12/09/20	Deleted Reconstruction Callout R6. Added Reconstruction Callout R5.
DATE	REVISION
STATE OF HAWAII DEPARTMENT OF TRANSPORTATION HIGHWAYS DIVISION	
ROADWAY PLAN	
Vineyard Blvd & Queen Emma St	
ADDITIVE ALTERNATE #1	
Traffic Signal Modernization, Oahu, Phase 1	
Federal-Aid Project No. STP-0300(163)R	
Scale: 1"=10'	Date: Oct. 2020
SHEET No. R-19 OF 81 SHEETS

Traffic Signal Modernization, Oahu, Phase 1

Federal-Aid Project No. STP-0300(163)R

PAVEMENT RESTORATION OVER CONCRETE JACKET DETAIL
Scale: 3/8" = 1'-0"

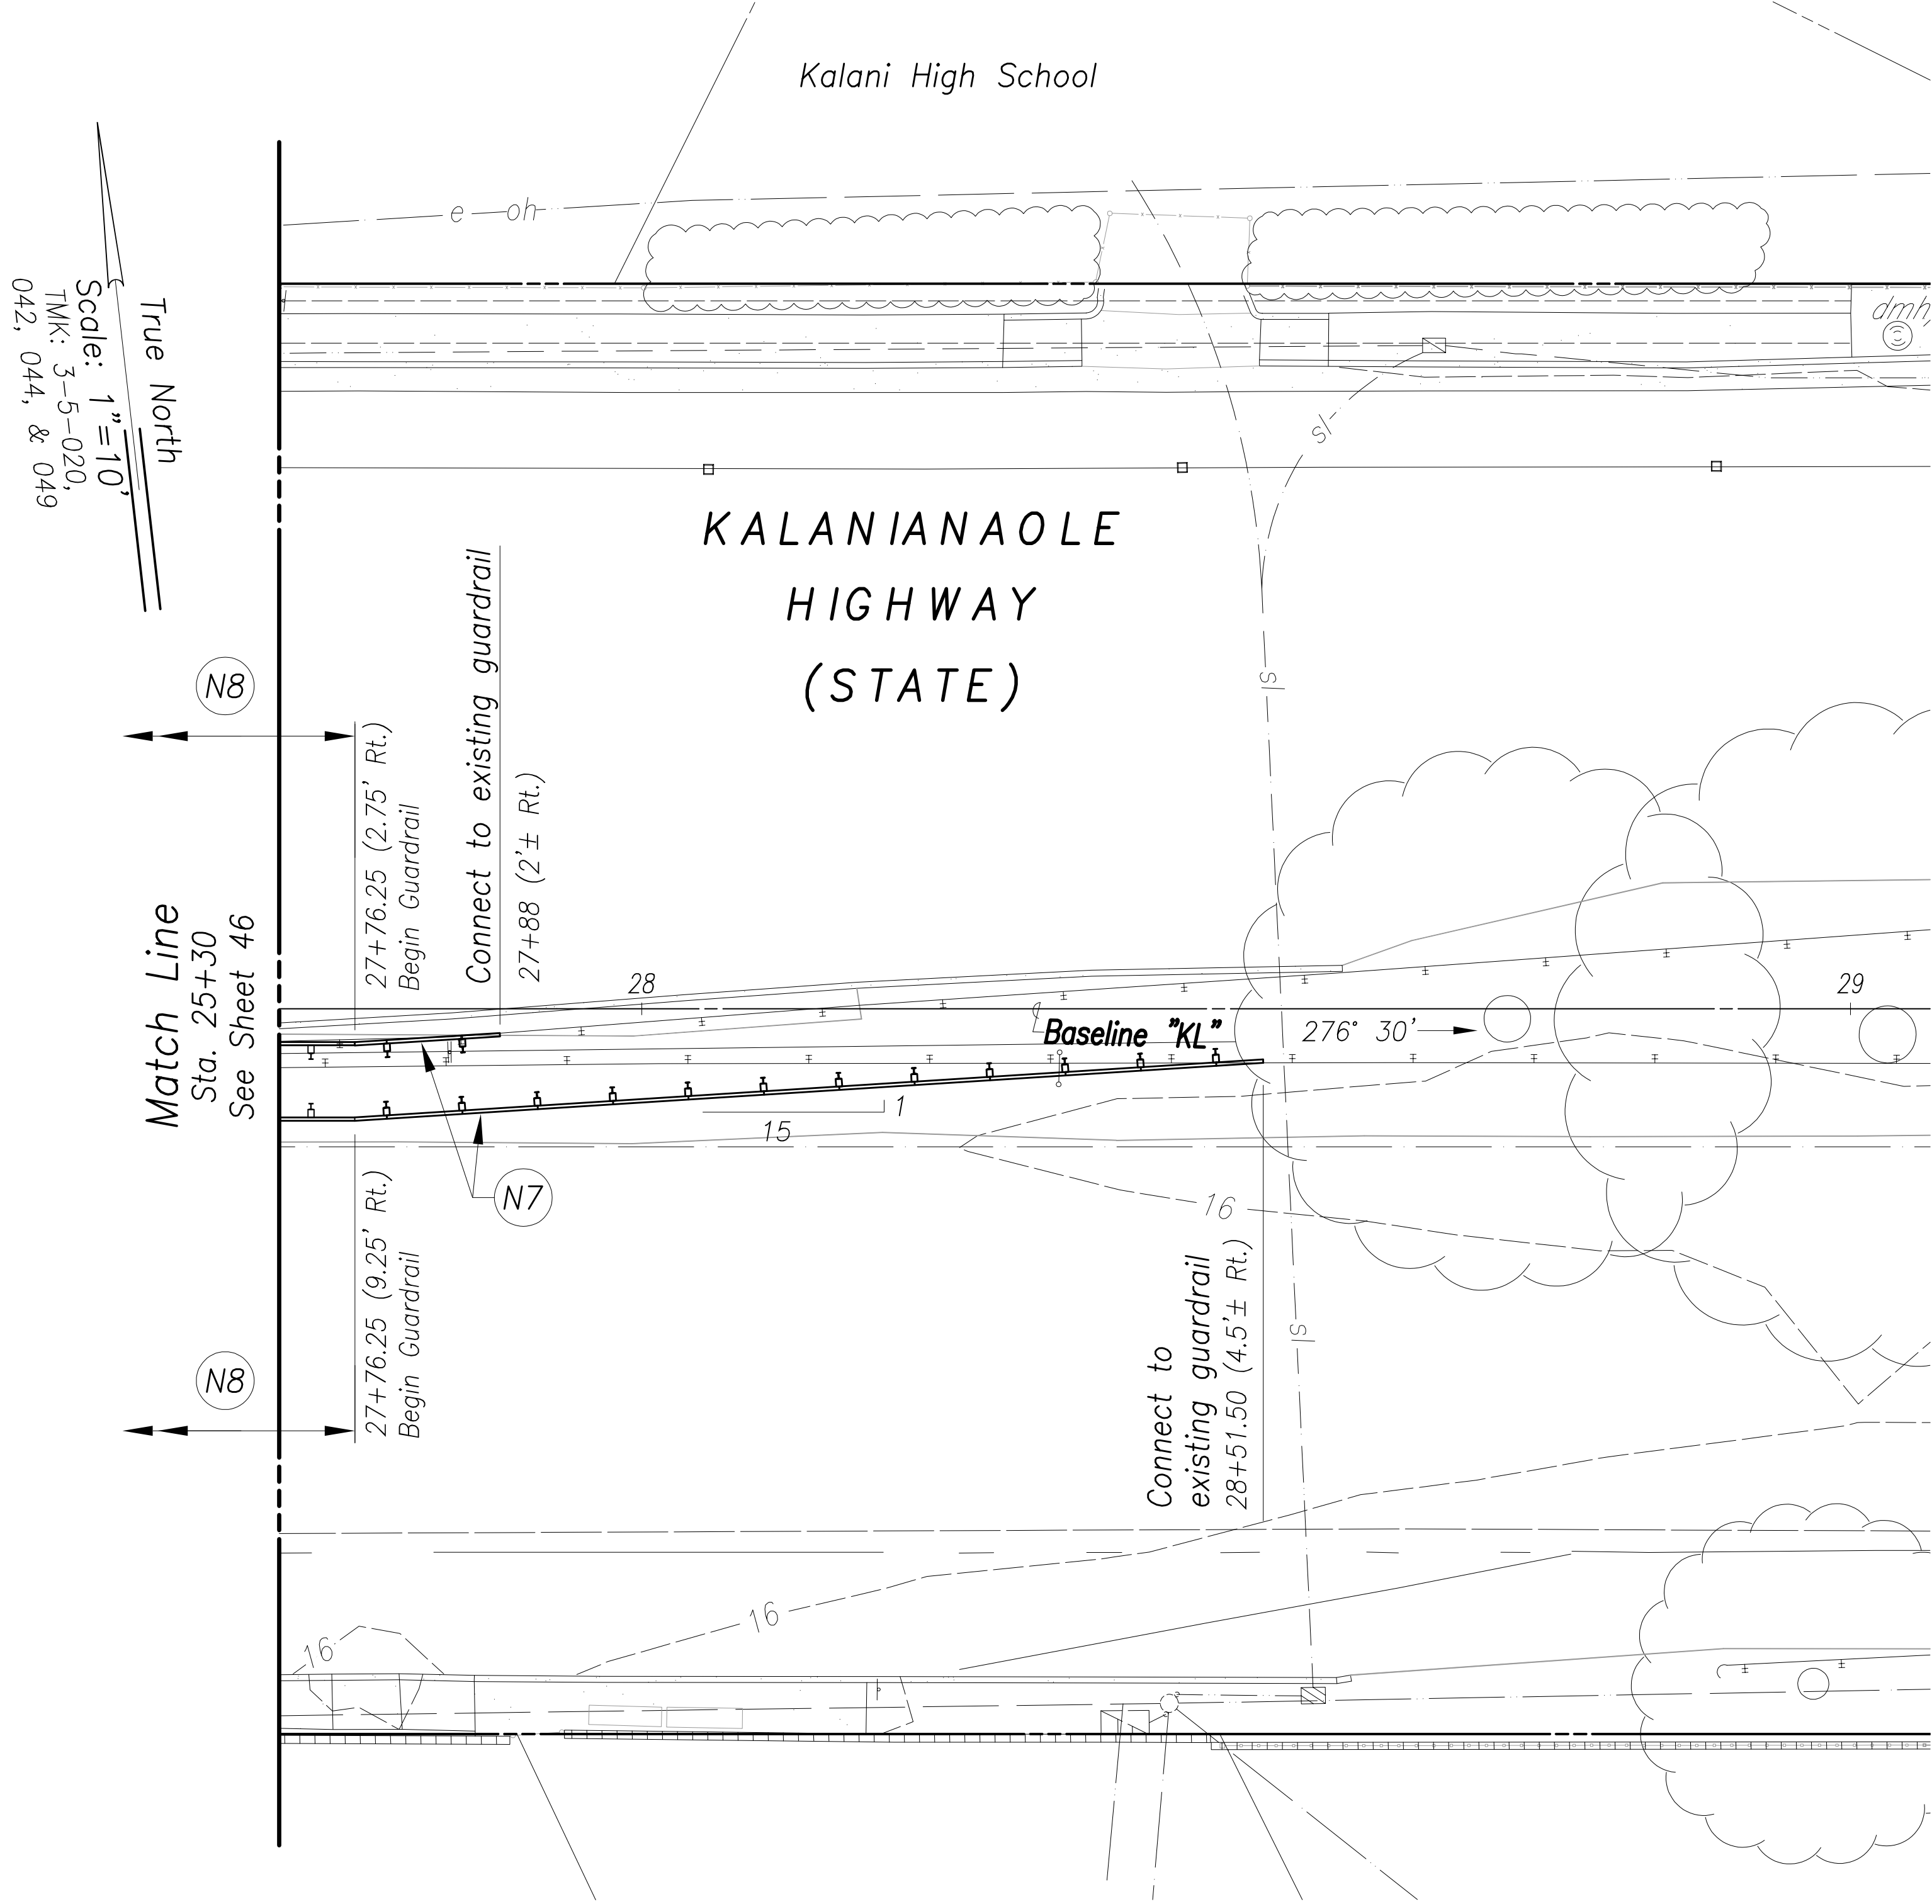
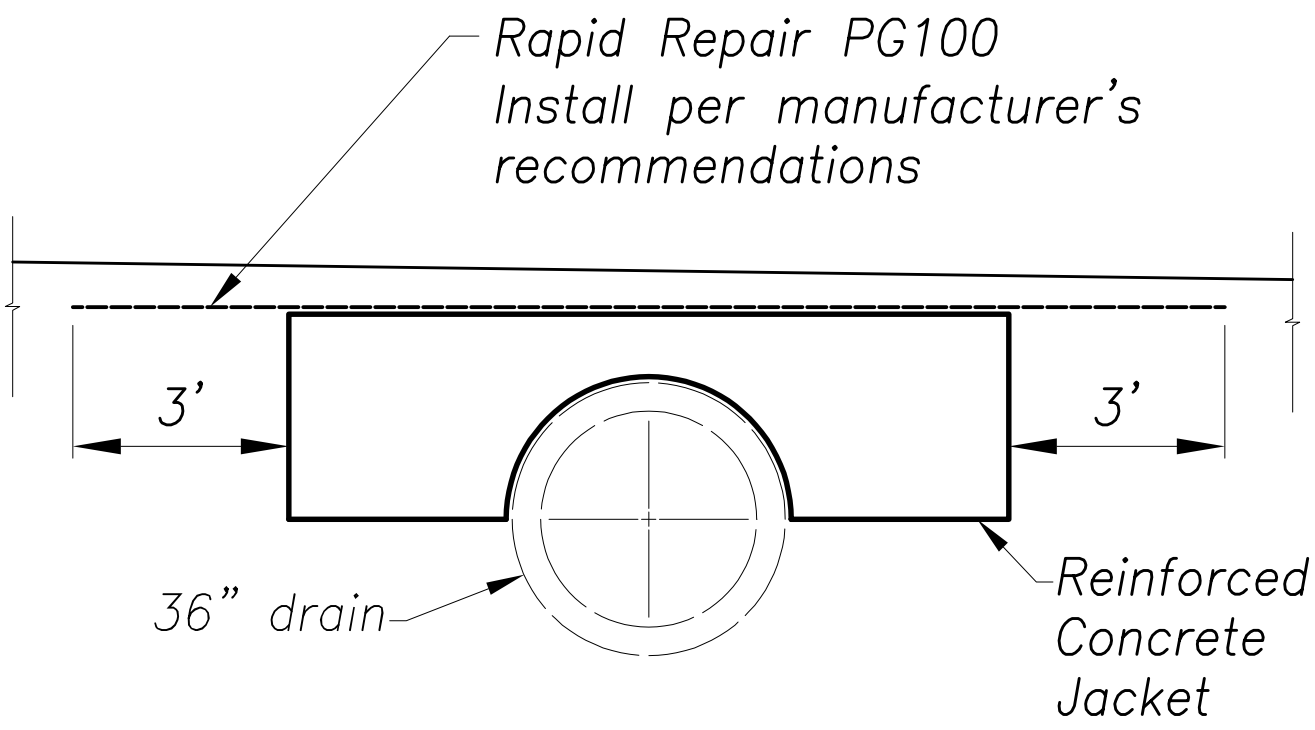
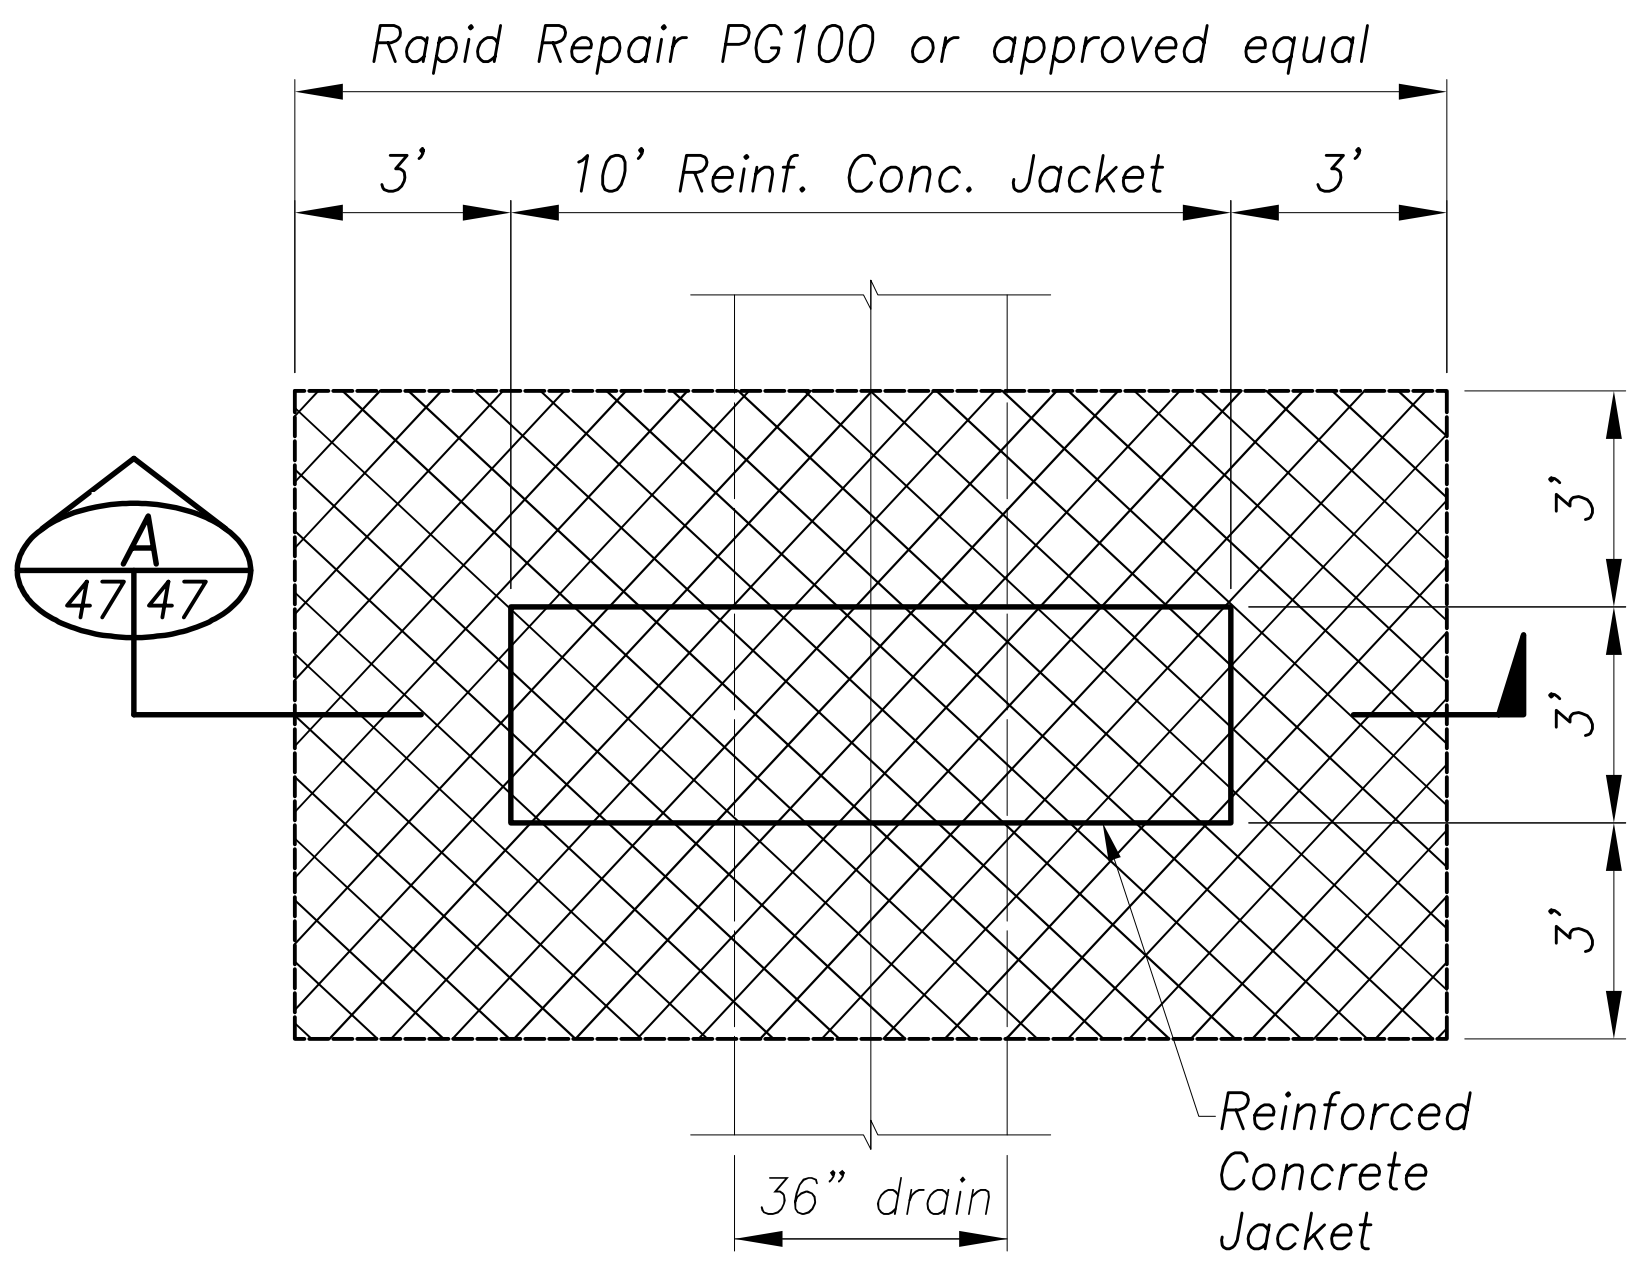
12/09/20	Called out beginning of new guardrail. Added New Construction Callout N8.
DATE	REVISION
STATE OF HAWAII DEPARTMENT OF TRANSPORTATION HIGHWAYS DIVISION ROADWAY PLAN Kalaniana'ole Hwy & Kalaniiki St ADDITIVE ALTERNATE #2 Traffic Signal Modernization, Oahu, Phase 1 Federal-Aid Project No. STP-0300(163)R Scale: 1"=10' Date: Oct. 2020 SHEET No. R-26 OF 81 SHEETS

TERMINAL IMPACT ATTENUATOR

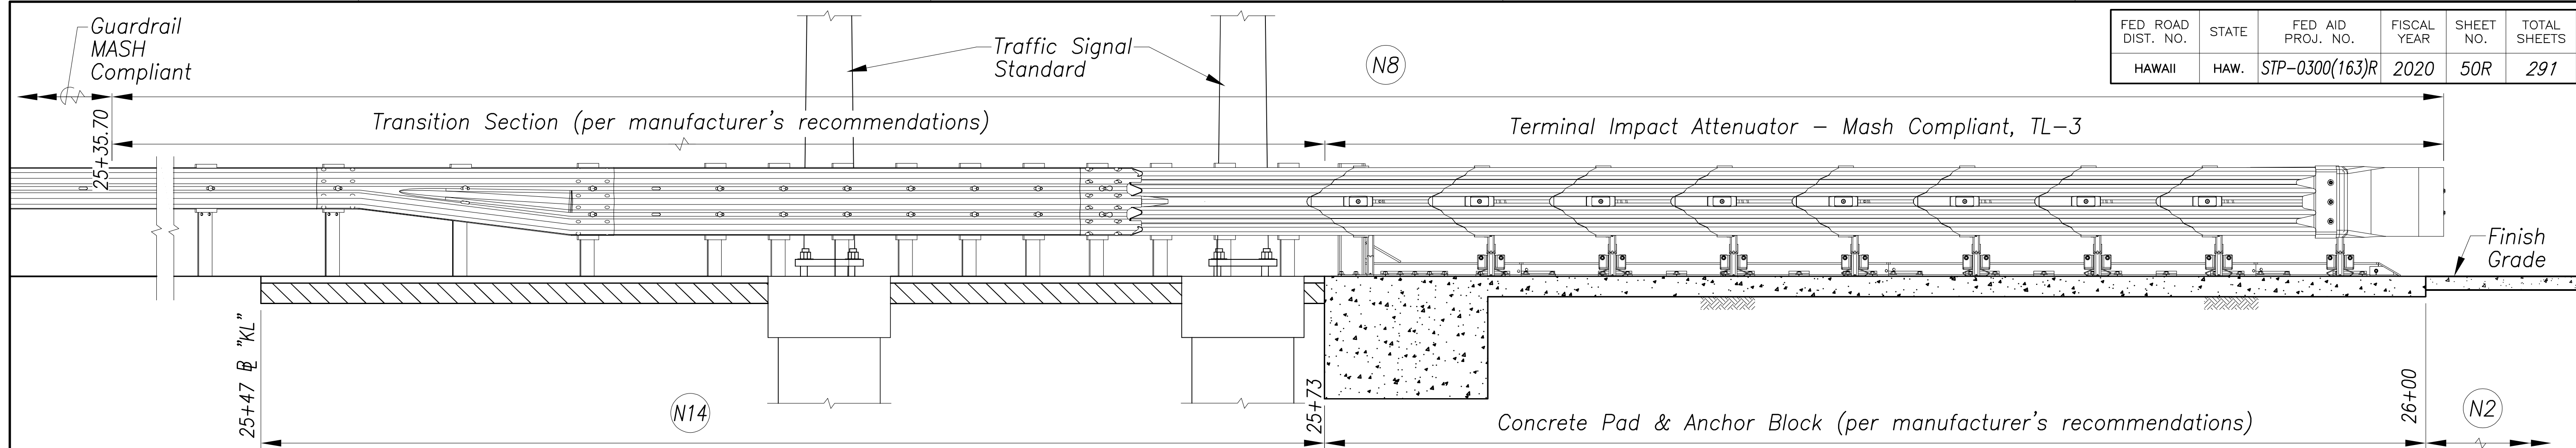
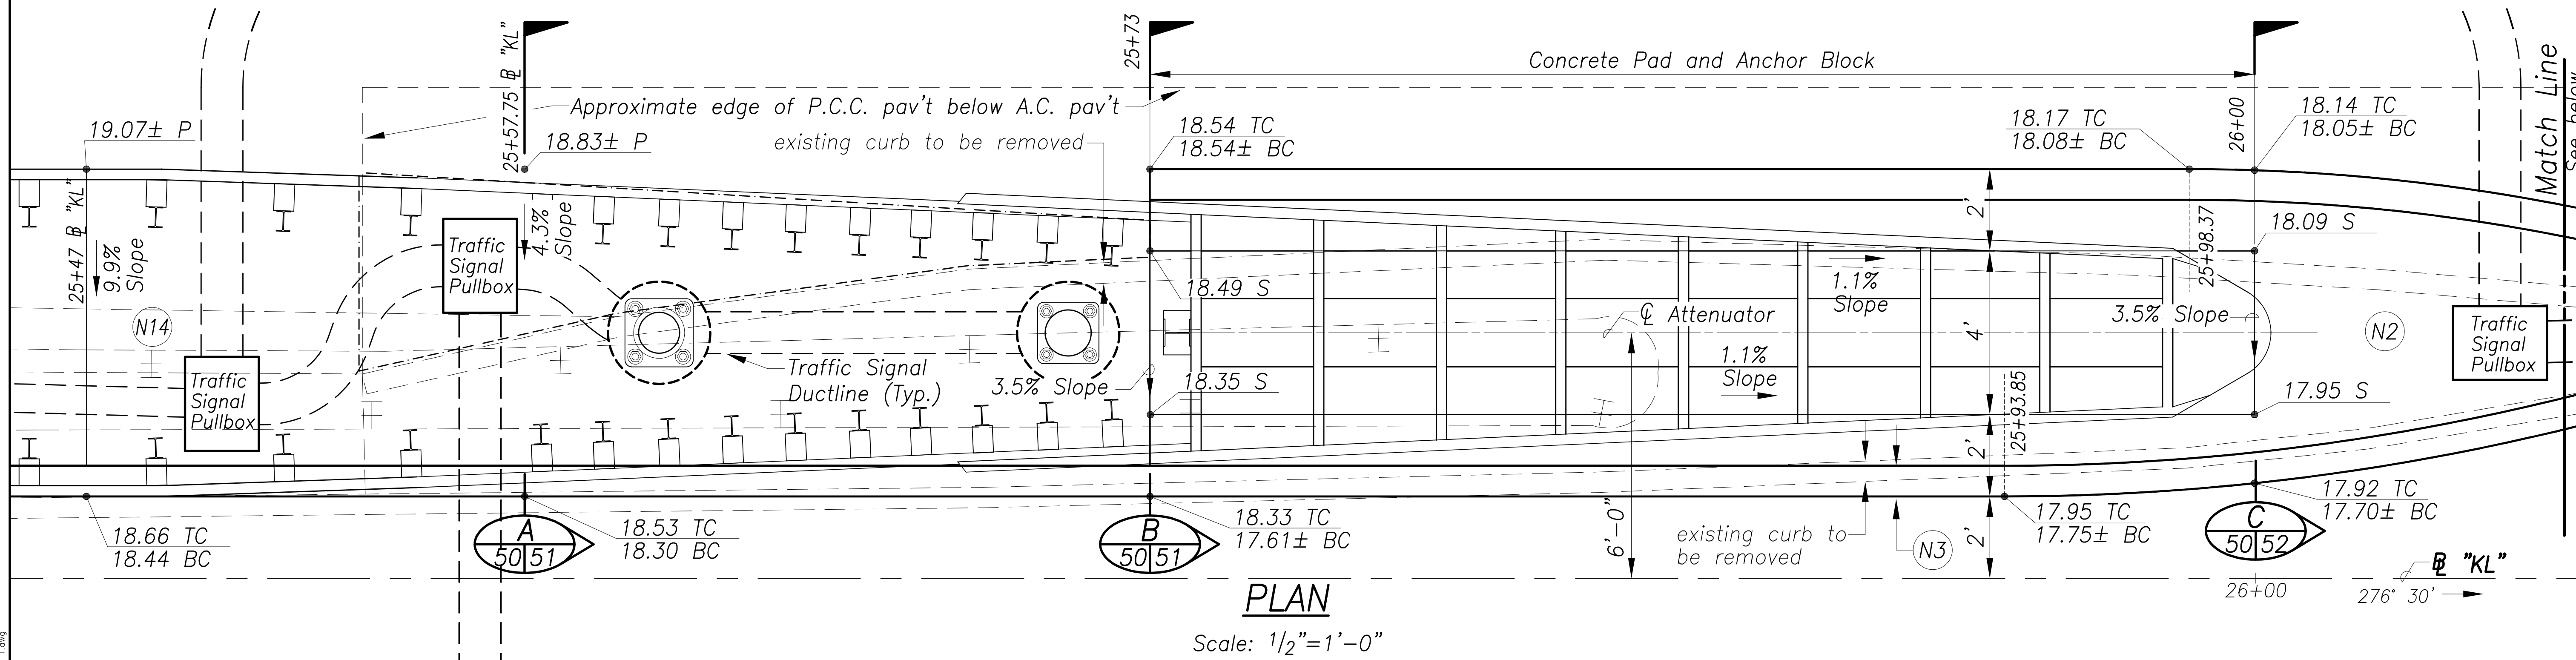
Added new construction callout N8.
Revised Elevation view and added N8.
